Technical Information Service 215/21 ENU WMQ3

WMQ3 - Retrofitting Loudspeaker Booster (Stop Delivery)

Model Line: Macan (95B)

Installation position

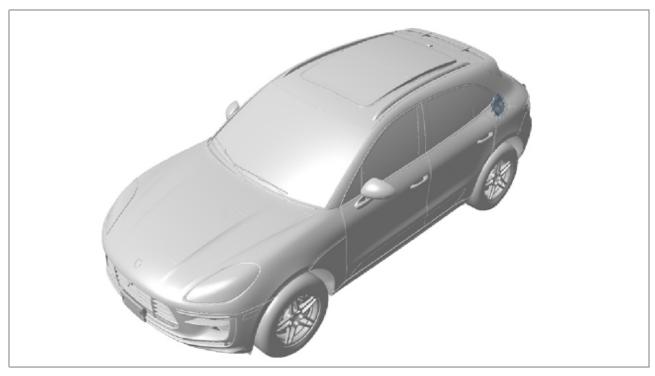
- (Retrofitting) loudspeaker booster
